MEMORANDUM

Subject: Marble Valley Mass Grading & Oakland Impact

The purpose of this Memo is to review the Proponent’s intentions as to mass grading on Marble Valley and to set forth the basis for registering a comment to the DEIR of May 2024.

Below: Excerpt of Figure B.8 Preliminary Rough Grading Exhibit, Site design Standards b-18 MVSP- Public review draft -May 2023

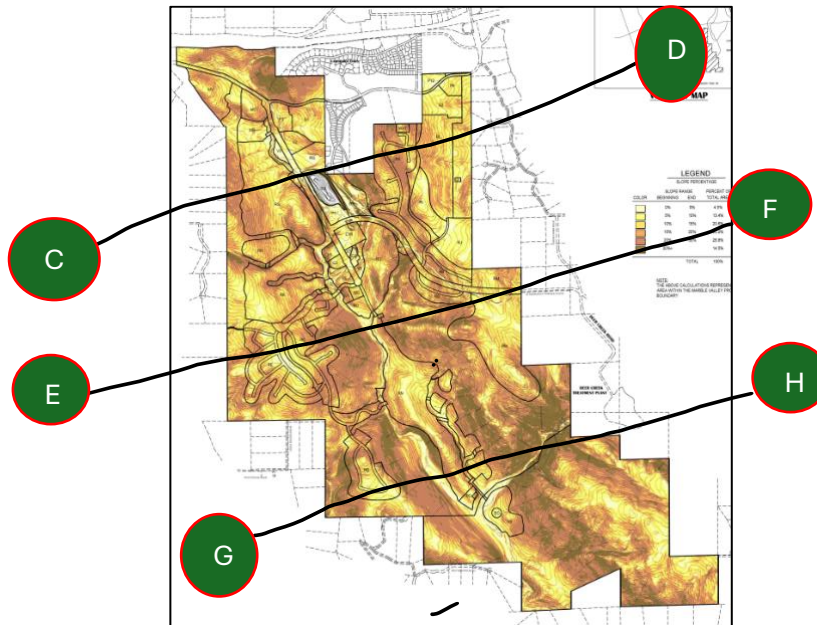
2. The slope analysis offered, using – albeit crude – Google Earth cross sections of the valley In Exhibit 3 attached, seeks to qualify the proponent’s intentions.
3. The rough grading plan – Figure B.8 (map) below - does not provide the details required for such an impact on Oakland canopy. The word “preliminary” underscores the need for greater detail.
4. The statements made in the texts provided in the DEIR and Proponent’s Marble Valley Specific Plan have many caveats and allow the proponent to seek ministerial approval of a plan. For 712 acres of grading, a mere ministerial approval?
5. The County’s on and offsite mitigation measures and in-lieu fees provide no disincentive to the proponent to undertake a more “sculptured” approach to grading and “avoid” eradicating all oaks over 78% of the residential acreage.

Just by visual inspection one may appreciate the impact of mass grading shall have.

1. Provide a detailed slope analysis of projects (or group of projects in a sub area) identifying the specific % slopes.
2. Provide a tree survey (identifying trees over 12” caliper) along with its georeferenced location in the areas to be mass graded.
3. Provide a rough grading plan for the above areas along with clusters of oak trees and individual trees to be “saved”.

Refer to map exhibit for cross section C > D

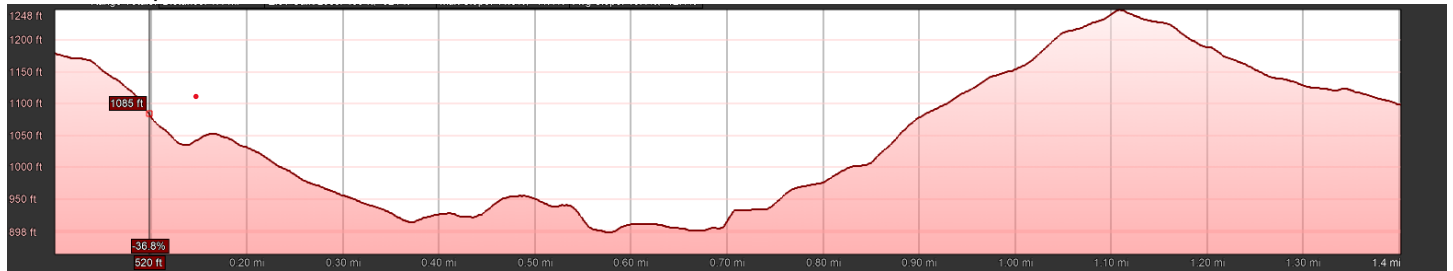
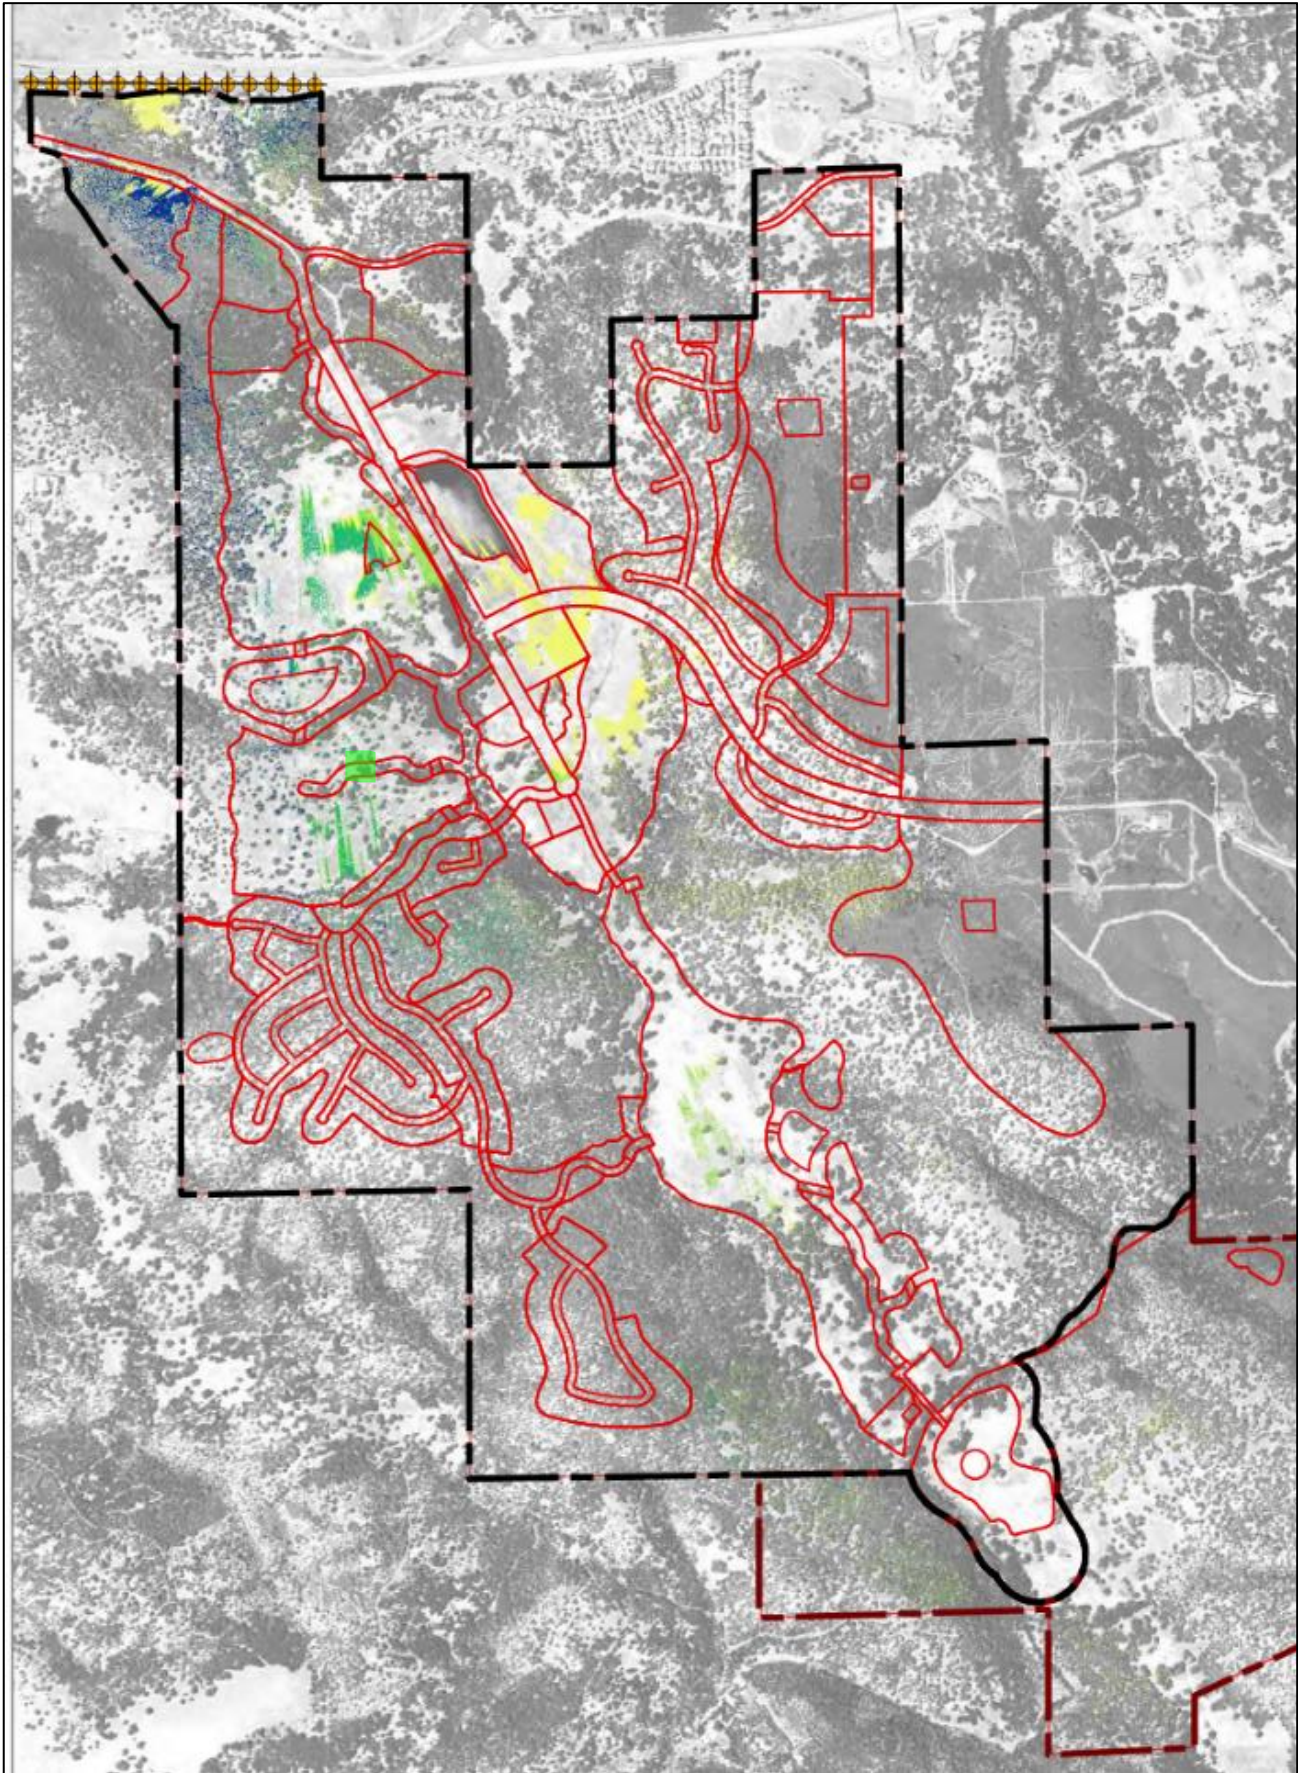
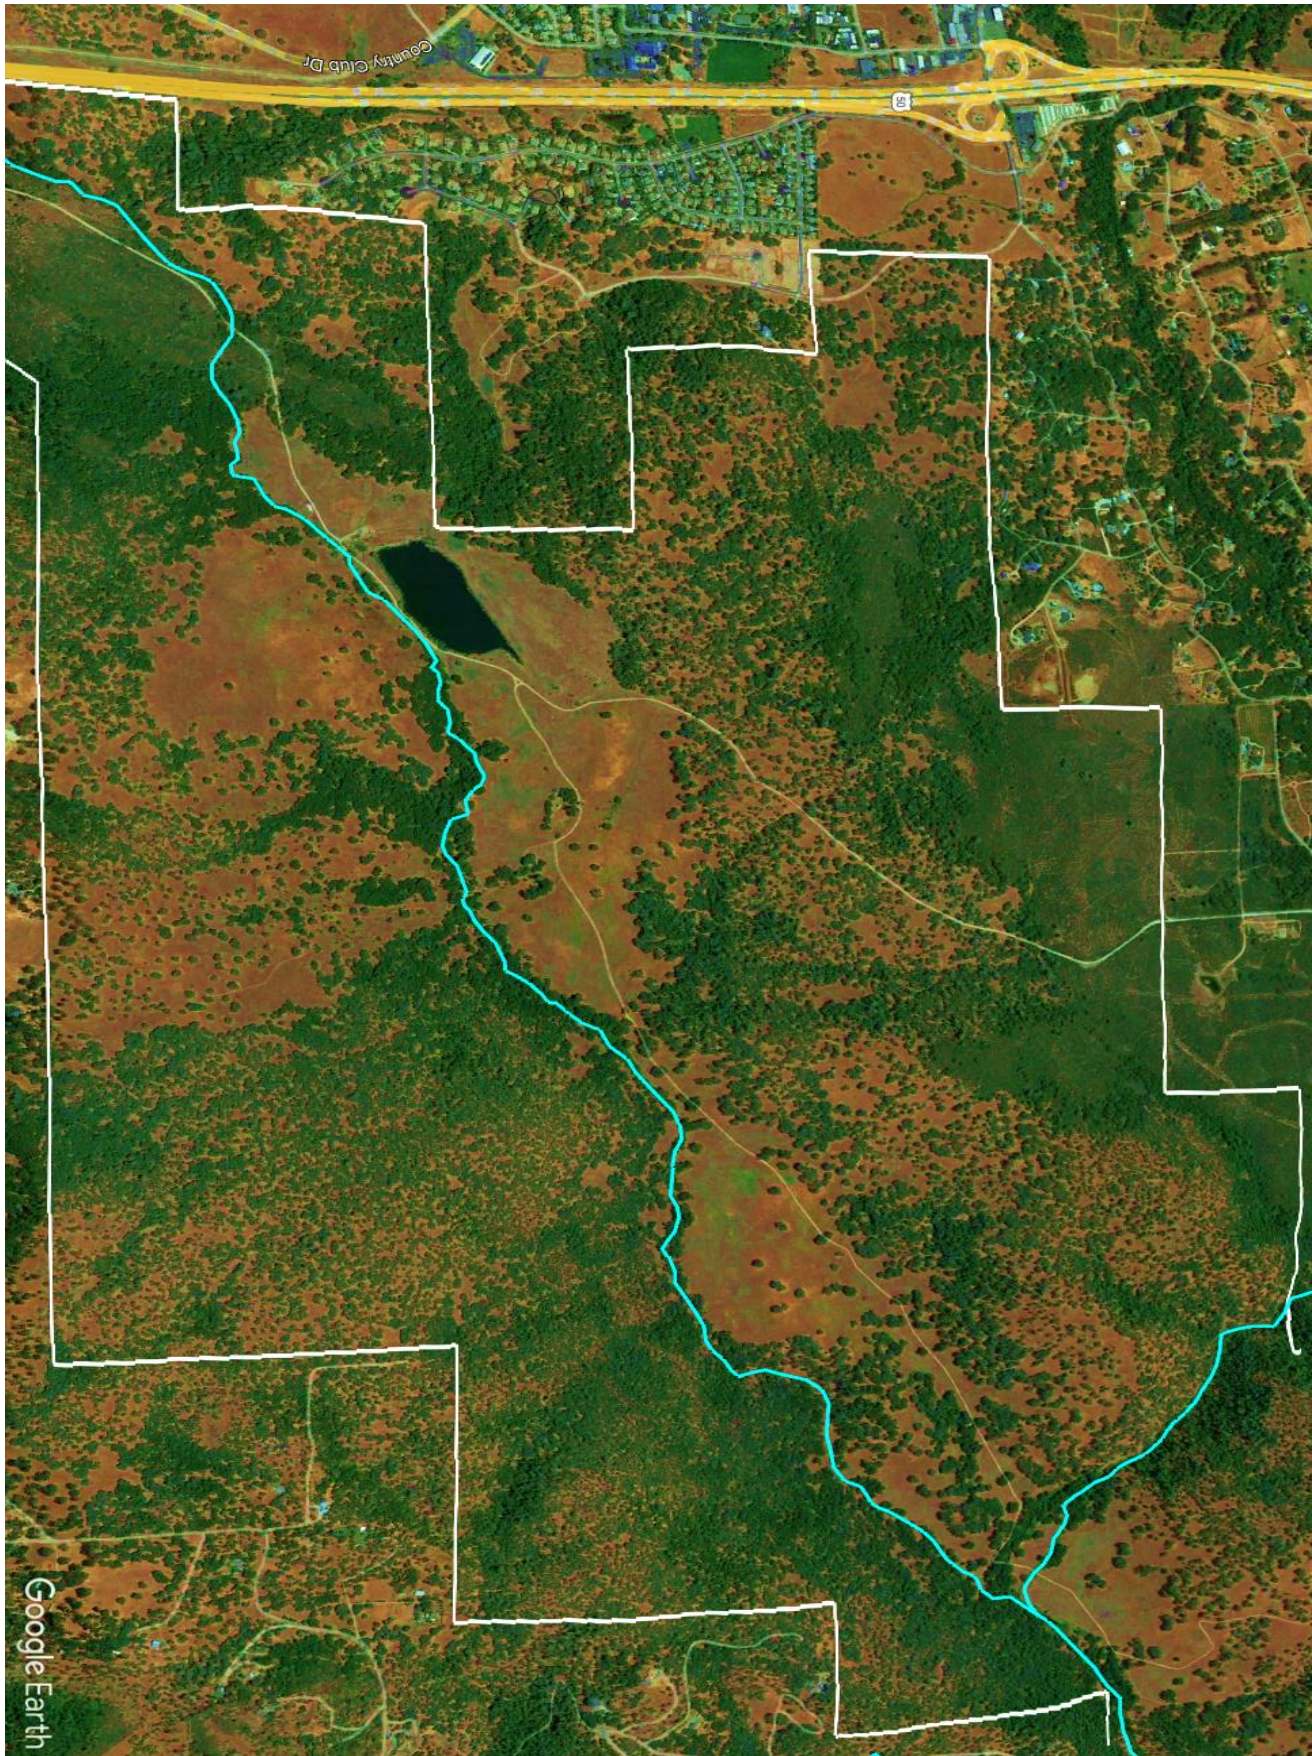
In the DEIR, page 3.5-10, the proponent cites Table 3.5-1: project Area Slope Information, to manifest that **30% slopes shall not be touched!** The map and cross sections are counter to the Proponent's manifestations.

Impact and mitigation maps

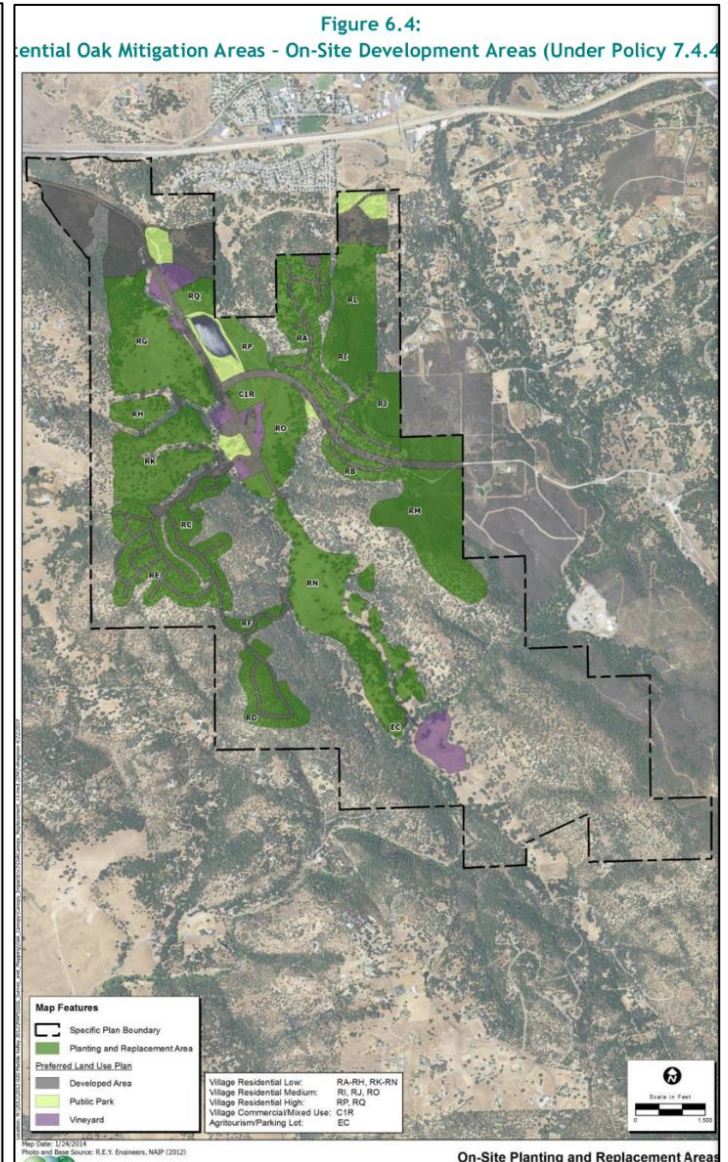
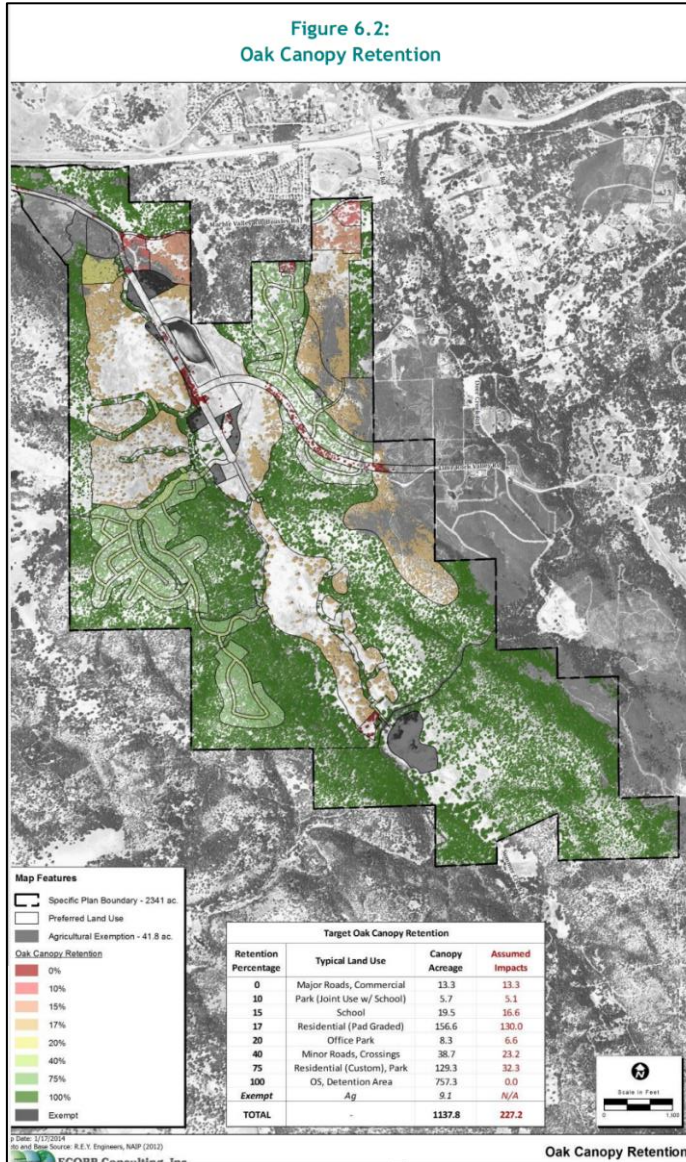
This is no small impact and mitigation on the areas rough graded?  
Does not present much logic.
